MADDOX PLACE SUBDIVISION

APPLICATION NUMBER Holdover DATE October 5, 2006
APPLICANT Maddox Place Subdivision
REQUEST Subdivision

DETAIL SITE PLAN

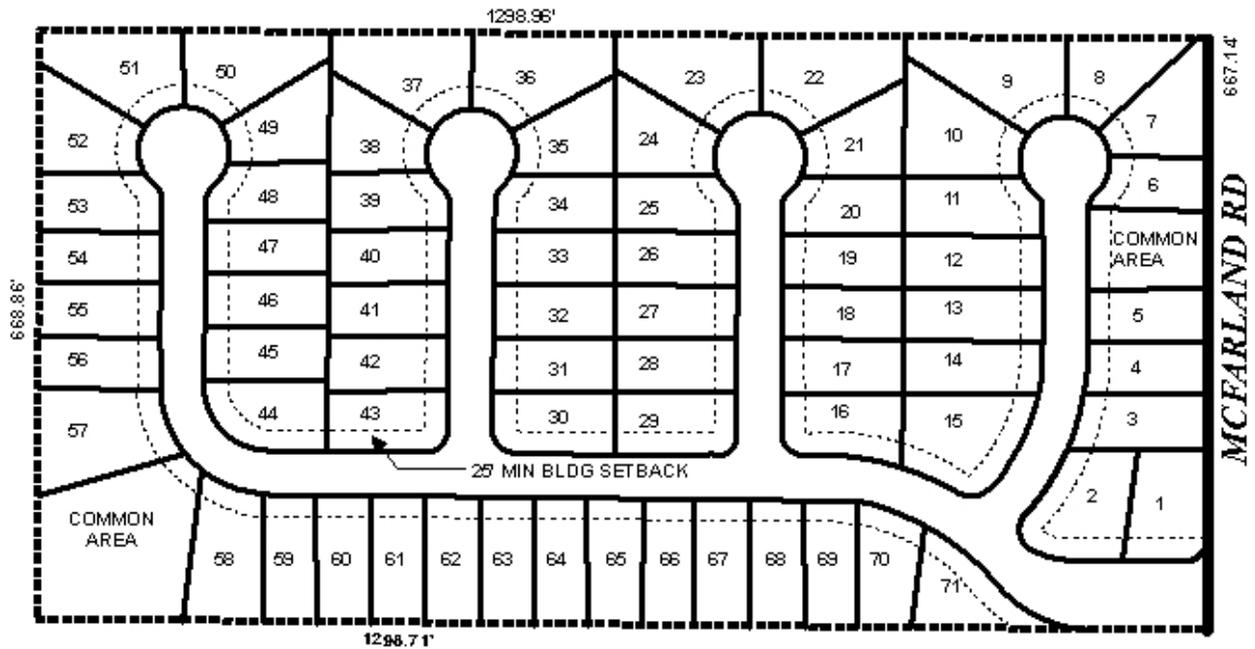
The site fronts McFarland Road, a minor street with a 60-foot right-of-way. Even though McFarland Road is a minor street, access management is a concern. A note should be placed on the plat stating that all lots and common areas fronting McFarland Road are denied access to McFarland Road.

The site has property lines at an intersection corner. Section V.D.6. of the Subdivision Regulations requires that “*property lines at street intersection corners shall be arcs having radii of at least 10 feet or shall be chords of such arcs.*” The plat should be revised to reflect this requirement at the South side of the McFarland Road intersection.

There appear to be discrepancies in some of the lot line measurements, though it does appear that all lots meet minimum size requirements. However, the plat should be revised to ensure that all depicted bearings and measurements are correct. Furthermore, the lots should be labeled with their size in square feet, or a table should be provided depicting the same information.

Two common areas are depicted on the preliminary plat. It is also implied that an island will be provided at the entrance to the subdivision. All common areas should be depicted on the plat, and a note should be placed on the final plat, if approved, stating that maintenance of the common areas is the responsibility of the subdivision’s property owners.

The 25-foot minimum building setback line, required in Section V.D.9., is depicted on the plat, but is not depicted for those lots with frontage onto McFarland Road. The plat should be revised to show the minimum building setback line from all streets.

Due to the drainage concerns identified at the meeting, it is recommended that compliance with the City of Mobile stormwater and flood control ordinances be required. A letter from a licensed engineer certifying compliance with the City's stormwater and flood control ordinances should be submitted to the Planning Section of Urban Development prior to the signing of the final plat, if approved.

1) placement of a note the plat stating that all lots and common areas fronting McFarland Road are denied access to McFarland Road; 2) revision of the plat to comply with Section V.D.6. of the Subdivision Regulations (*property lines at street intersection corners shall be arcs having radii of at least 10 feet or shall be chords of such arcs*) at the McFarland Road intersection; 3) depiction and labeling of all common areas; 4) placement of a note on the final plat stating that maintenance of the common areas is the responsibility of the subdivision's property owners; 5) depiction of the 25-foot minimum building setback line from all streets; 6) revision of the plat to correct any discrepancies regarding lot line measurements or bearings; 7) labeling of all lots with size in square feet, or placement of a table on the plat containing the lot size information; and 8) placement of a note on the final plat stating that any lots which are developed commercially and adjoin residentially developed property must provide a buffer, in compliance with Section V.A.7. of the Subdivision Regulations.

Based upon the preceding, the plat is recommended for Tentative Approval subject to the following conditions: 1) placement of a note the plat stating that all lots and common areas fronting McFarland Road are denied access to McFarland Road; 2) revision of the plat to comply with Section V.D.6. of the Subdivision Regulations (property lines at street intersection corners shall be arcs having radii of at least 10 feet or shall be chords of such arcs) at the McFarland Road intersection; 3) depiction and labeling of all common areas; 4) placement of a note on the final plat stating that maintenance of the common areas is the responsibility of the subdivision's property owners; 5) depiction of the 25-foot minimum building setback line from all streets; 6) revision of the plat to correct any discrepancies regarding lot line measurements or bearings; 7) labeling of all lots with size in square feet, or placement of a table on the plat containing the lot size information; 8) placement of a note on the final plat stating that any lots which are developed commercially and adjoin residentially developed property must provide a buffer, in compliance with Section V.A.7. of the Subdivision Regulations; and 9) provision of a certification letter from a licensed engineer to the Planning Section of Urban Development, certifying that the stormwater detention and drainage facilities comply with the City of Mobile stormwater and flood control ordinances, prior to the signing and recording of the final plat.
